RICHMOND COMMUNITY SCHOOL
Richmond High School: Mechanical Modernization Project
LWC Commission No. 20104.02

ADDENDUM #02
September 24, 2021

LWC, Inc.
712 EAST MAIN ST
RICHMOND, IN 47374

Comm. No.	Date
20104.02	9.10.2021
Drawn	Drawing No.
JLK	M204
Checked	
NPR

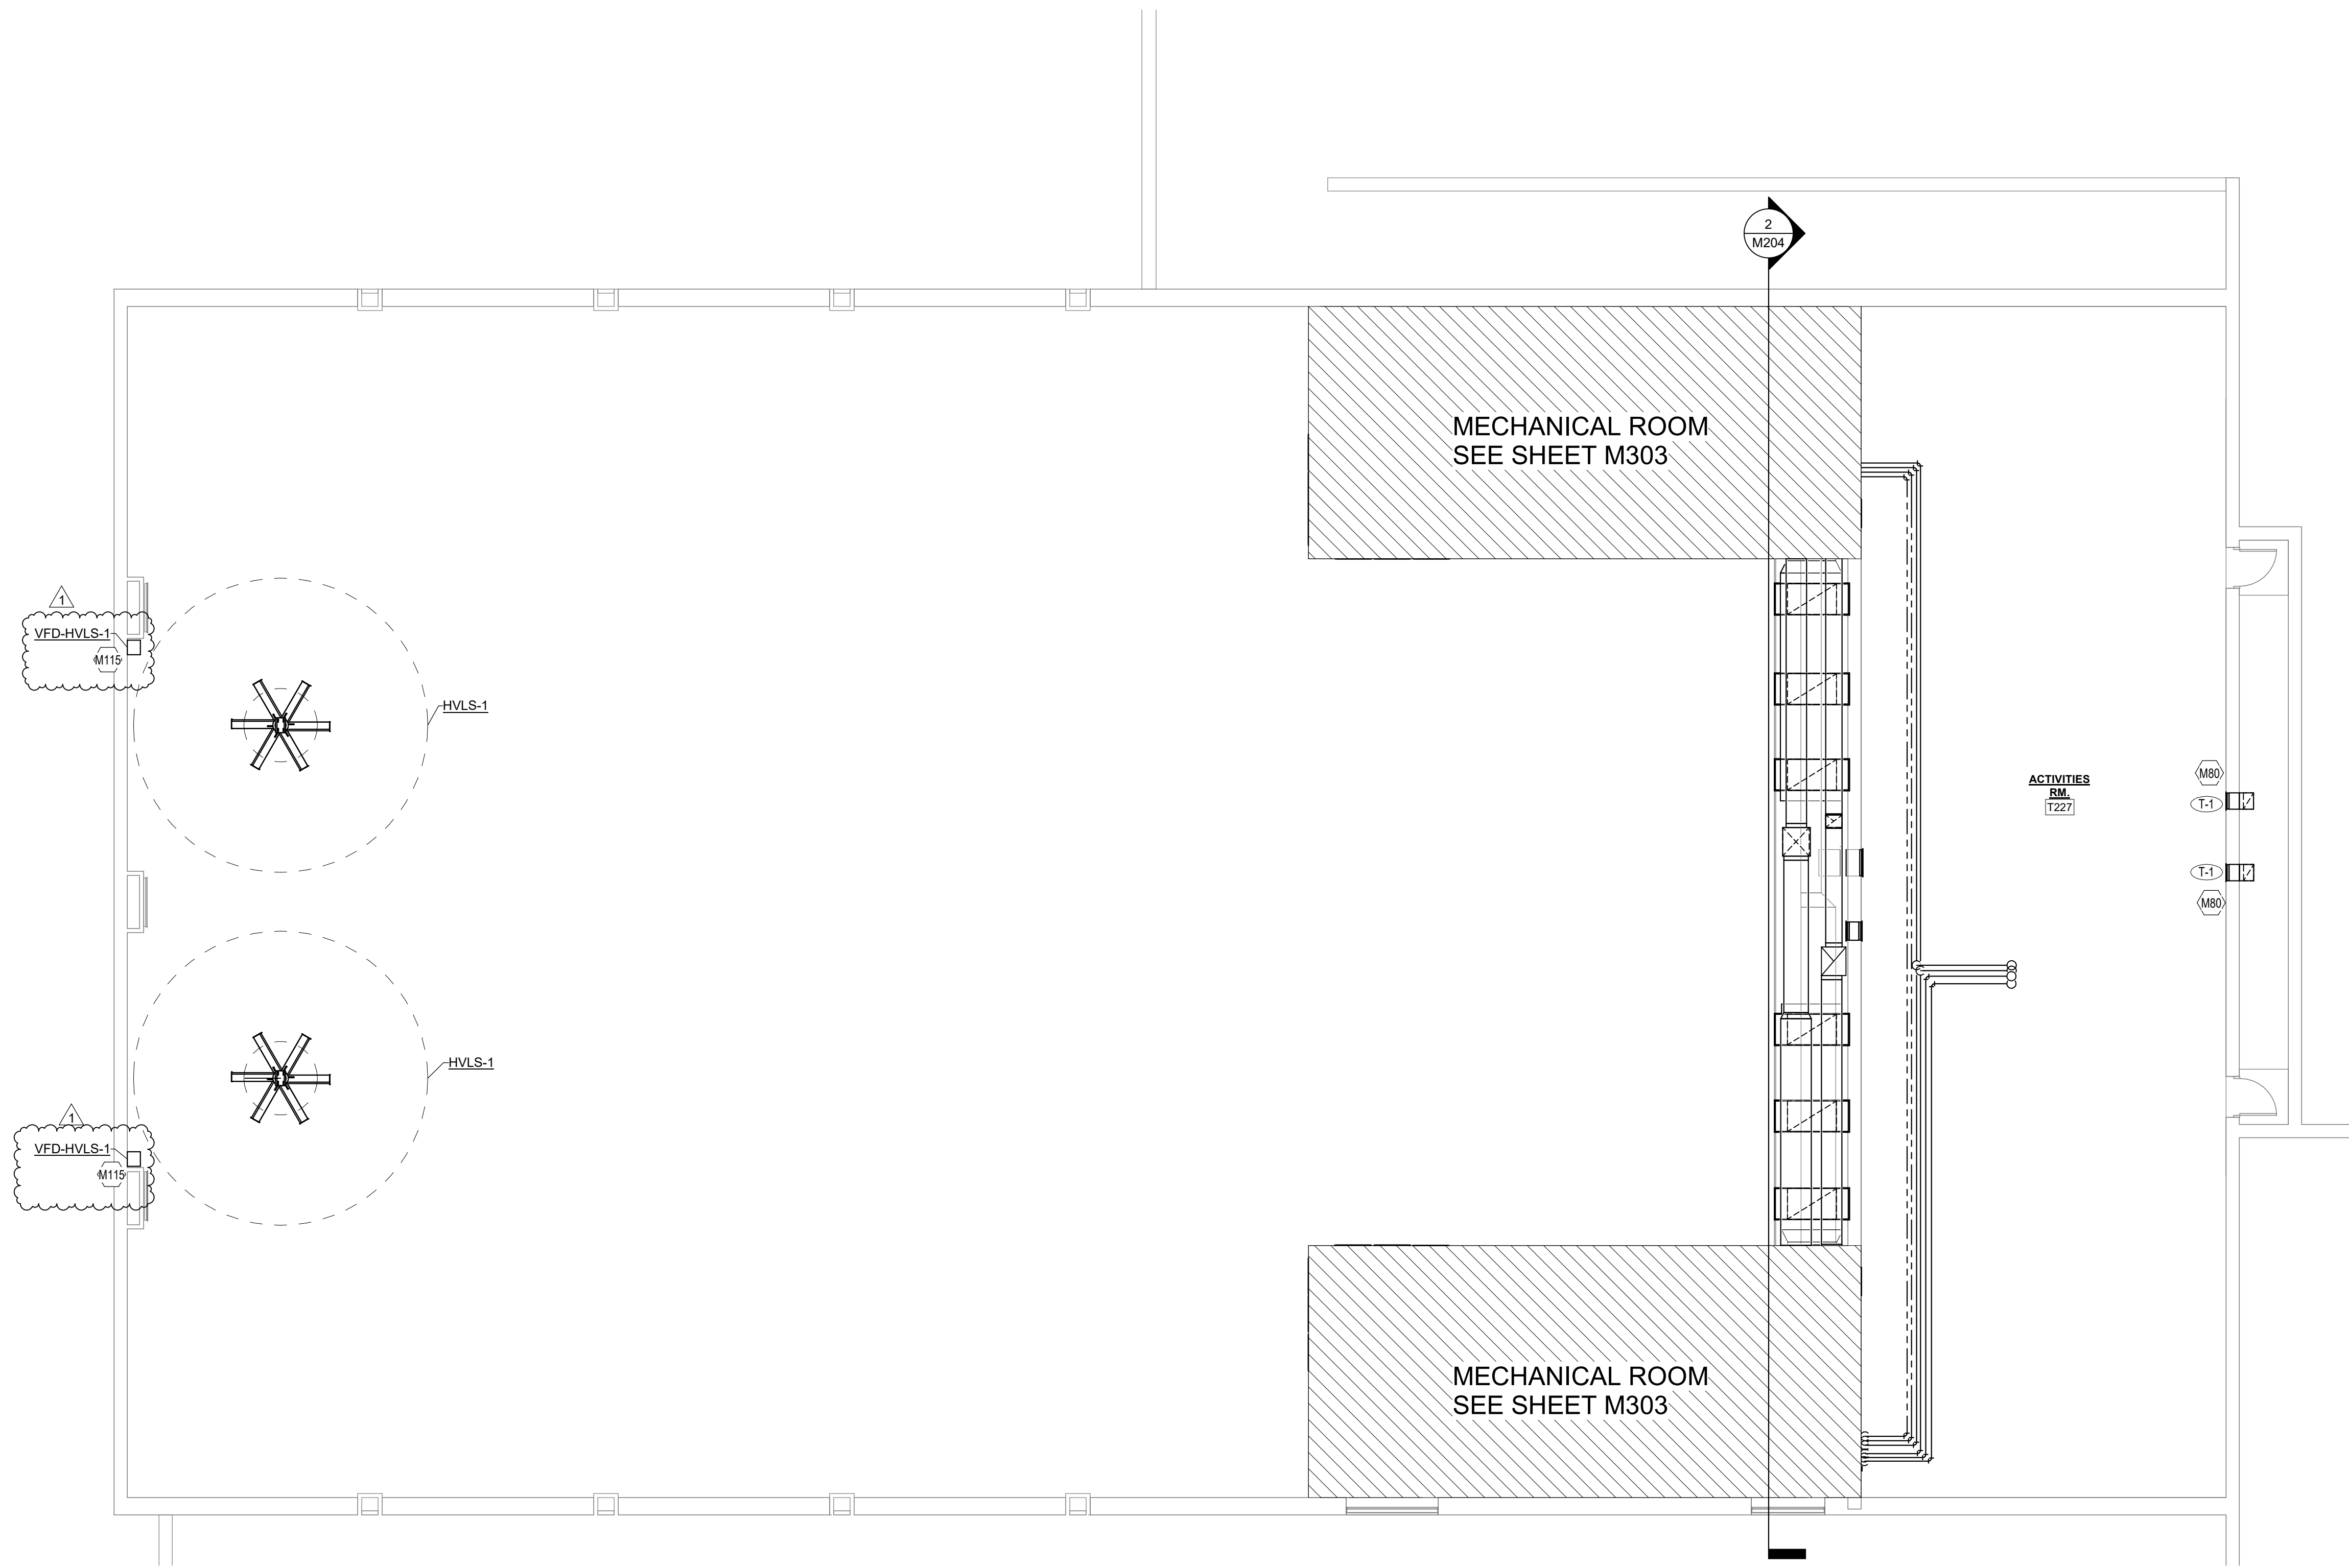
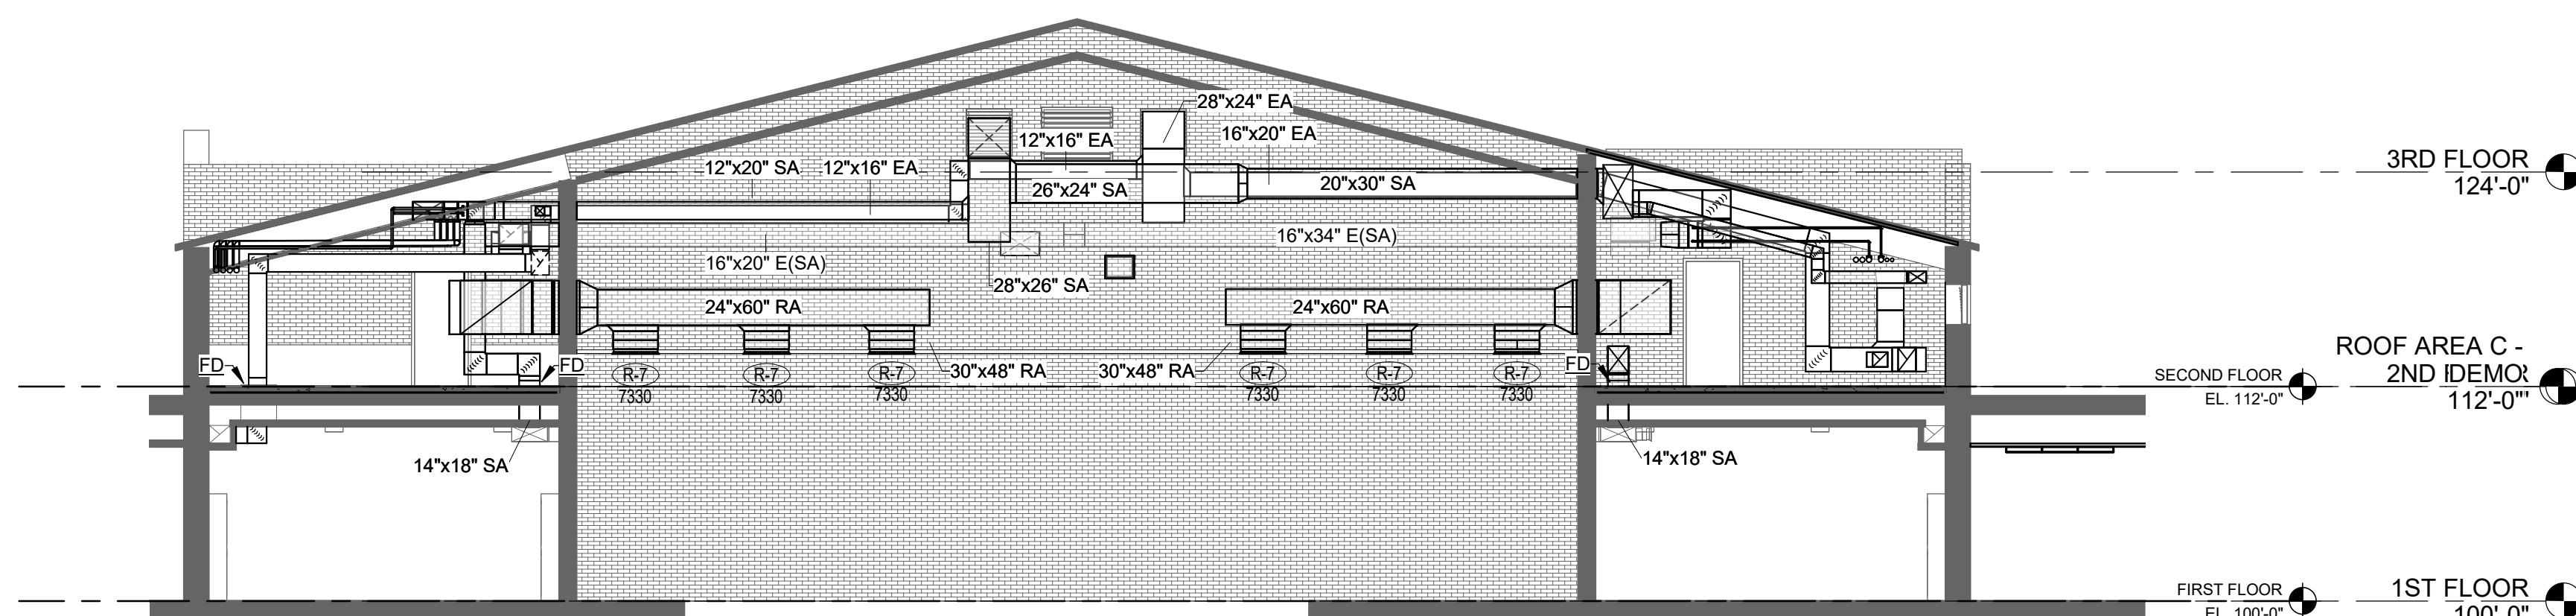
- A. Moved VFD controller near structure to maintain 25ft requirement.

- M80 COORDINATE TRANSFER GRILLE LOCATION WITH EXISTING WALL FIXTURES.
- M115 HVLS FAN VFD CONTROLLER SHALL BE WITHIN 25FT OF HVLS FAN AND MOUNTED NEAR STRUCTURE.
